Bulletin 02/2017
DMSB Circuit Regulations Appendix 2
Particularities for the Nürburgring Nordschleife 2017

The following amendments and supplements are applicable with immediate effect
(Amendments/supplements relating to Bulletin 01/2017 are shown in *italics*)

**The text of Bulletin 01/2017 to the DMSB Circuit Regulations, Appendix 2,
from 24. February 2017 is specified and replaced by the following text.**

Schnitt A-A [1]
Capless geschlossen

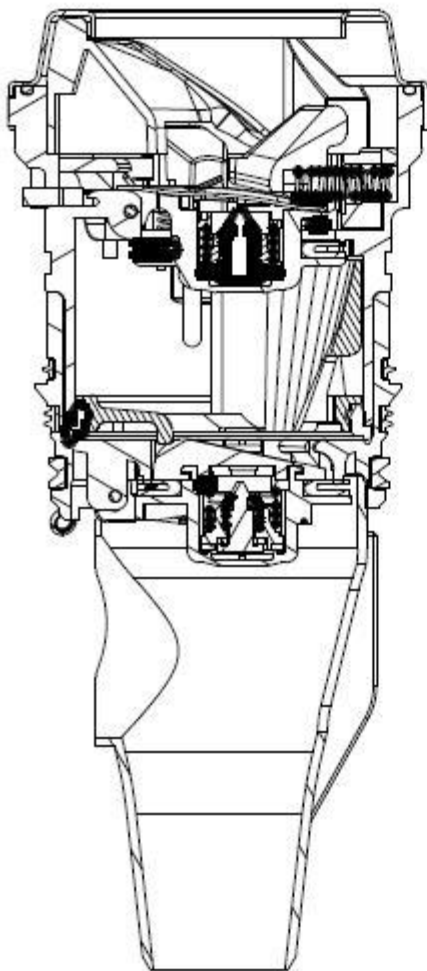
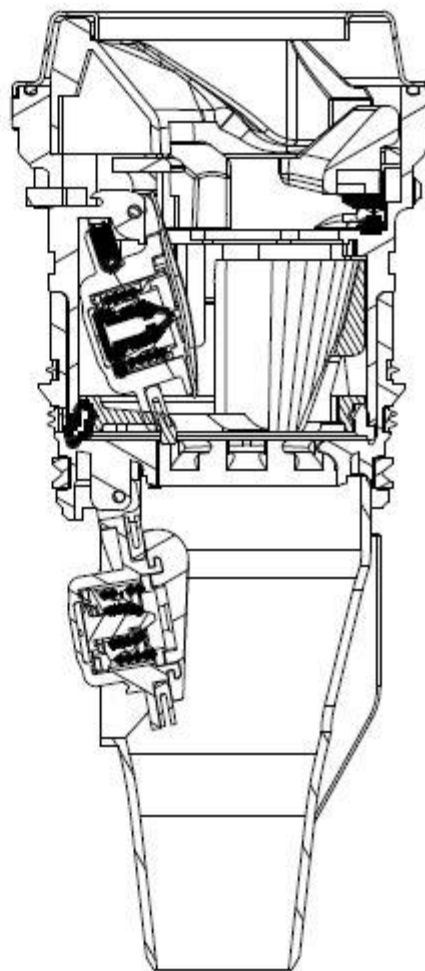
A two-stage safety non-return flap valve must be used for refuelling the car during the event (e.g. *Manthey-TZN Capless 2-3*).

For safety reasons, an additional fuel-tight closure (valve/sealing cap) must seal the exterior filler opening.

The safety flap valve in form of a sample part and drawing, including functional description, must be submitted to the Technical Commission/DMSB for approval.
